**TOWN GRAY**  
**ZONING BOARD OF APPEALS**  
**AGENDA • JANUARY 27, 2021**

Sharline Conroy is seeking a variance request to consider height for the reconstruction of a single-family dwelling located at 136 Birchwood Road, as shown on Tax Map 18, Lot 307-25, located in the Limited Residential (Shoreland) Zoning District. Dwellings within 25-75 feet of the normal high-water line in Limited Residential (Shorleand) Zoning District cannot exceed a 20-foot maximum building height.

RE: Sharline & Dennis Conroy Variance Appeal; 136 Birchwood Road (Map LS-7, Lot 25)

**SITE OBSERVATIONS**  
 JOB 17-14 FD'N WALL FIRE DAMAGE  
 SHEET NO. 1 OF 2  
 CALCULATED BY JFN DATE 6-13-17  
 CHECKED BY \_\_\_\_\_ DATE \_\_\_\_\_  
 SCALE 136 BIRCHWOOD RD., GRAY, ME

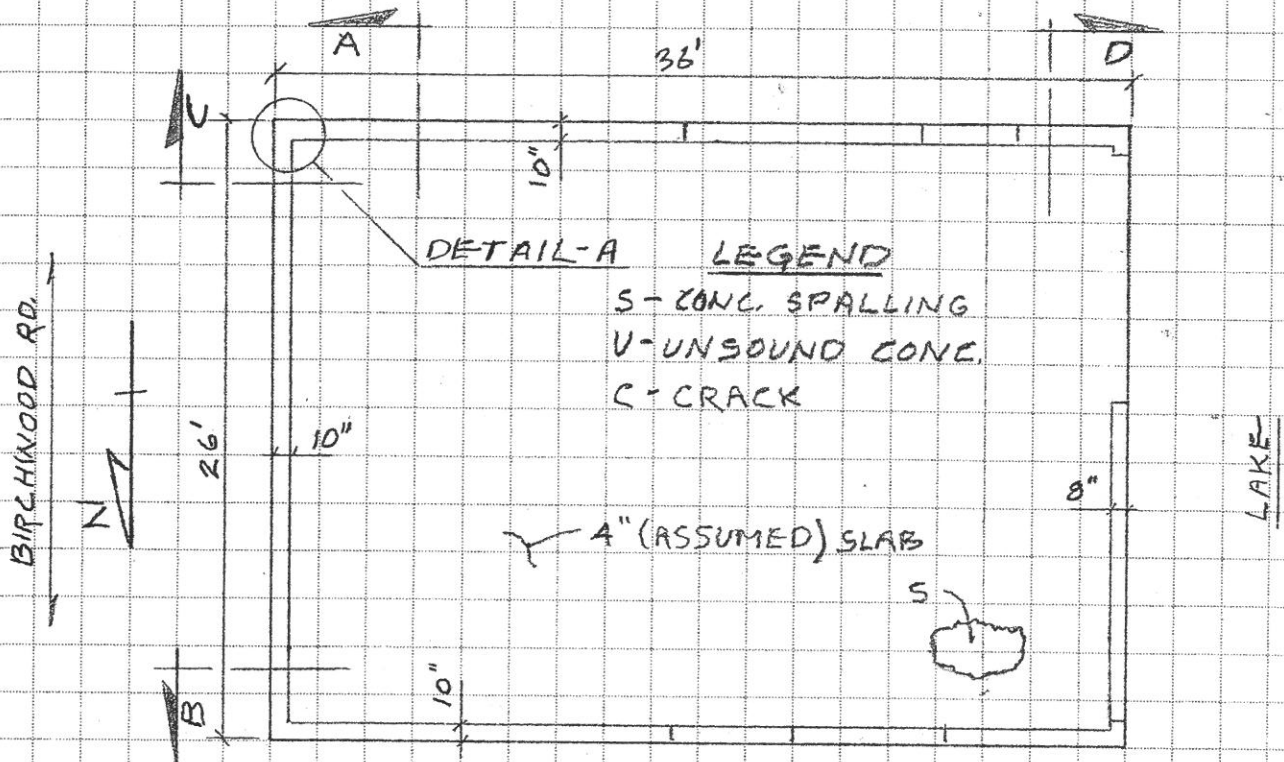
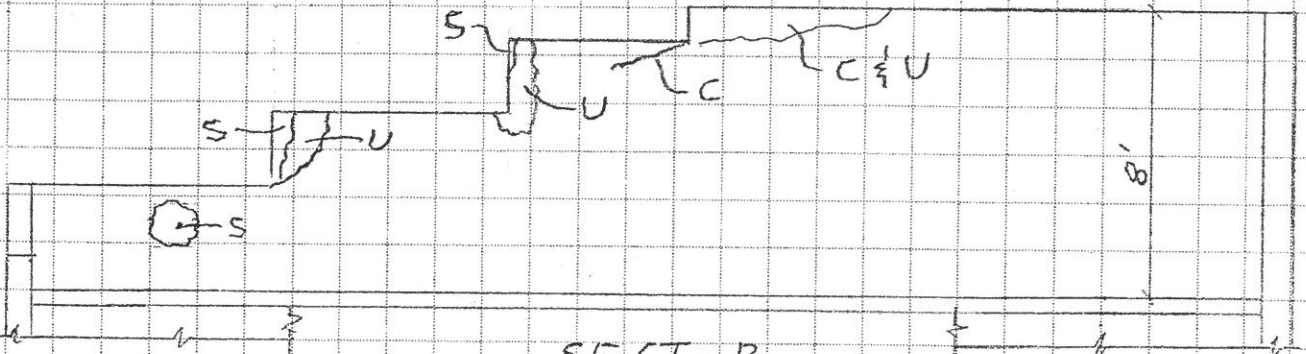
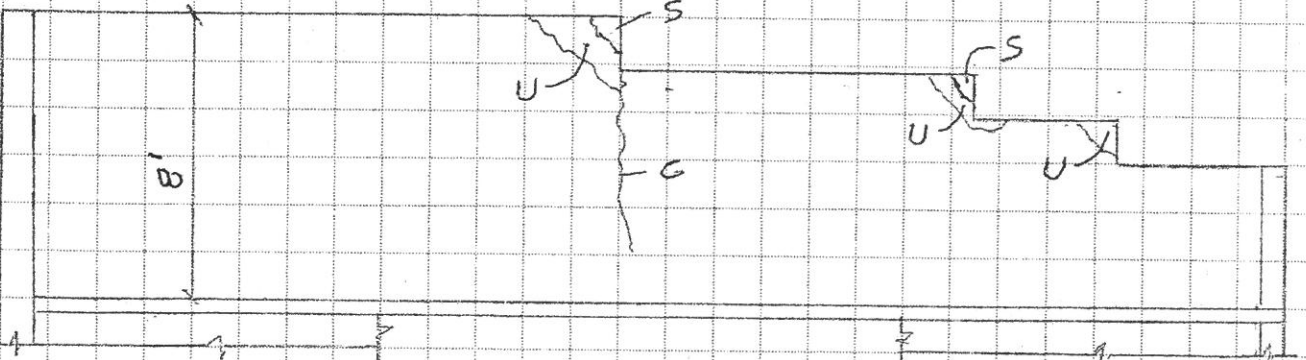
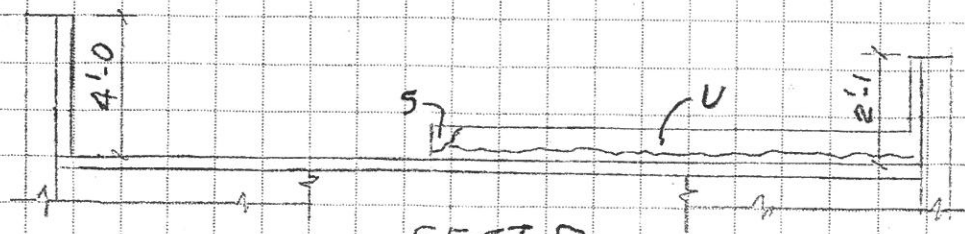
Based on the scope of testing, concrete spalling, unsound concrete and cracks are noted on the enclosed sheets 1 & 2.

The areas of concrete that are spalled, unsound and cracking can be structurally repaired. The repairs should be done by a specialty concrete repair/restoration contractor and not by a typical residential concrete contractor. There are a number of repair methods that they could recommend. Additional areas of repair may be found during their work.

CROSS SECTION A  
SCALE = 1/4" = 1'0"

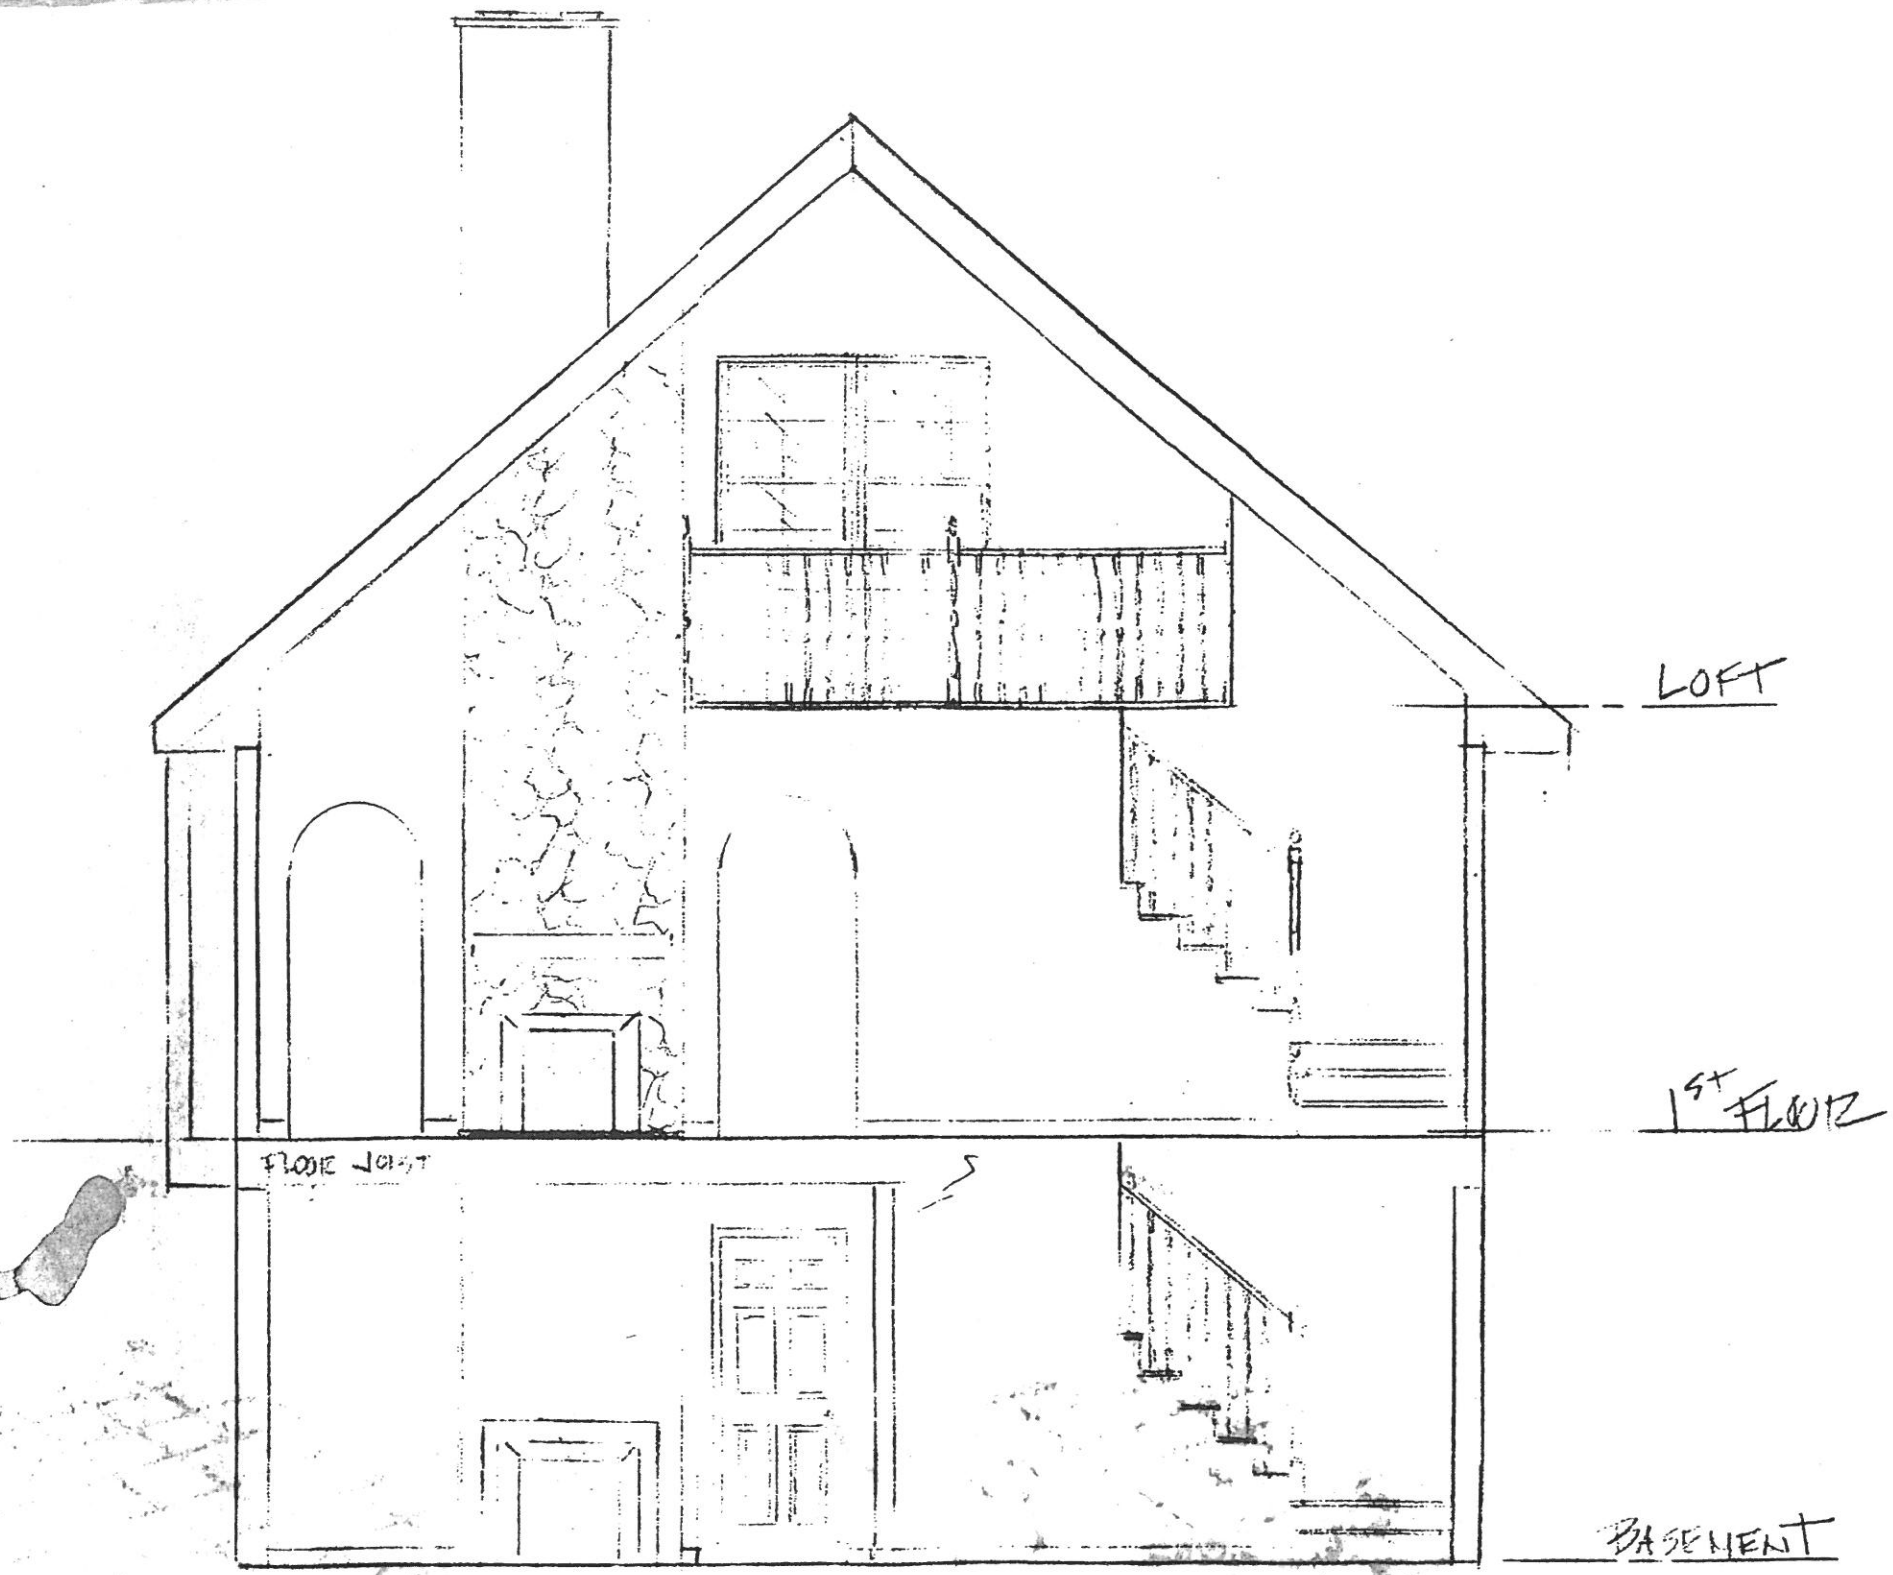
Act can be applied. Assuming, for discussion only, that the proposed dwelling location is at the greatest practical extent, the materials provided appear to be proposing a 31-foot high structure in a location where a new structure is limited to 20 feet in height. This however is not clearly stated in the application and requires making assumptions and estimates from the information provided.
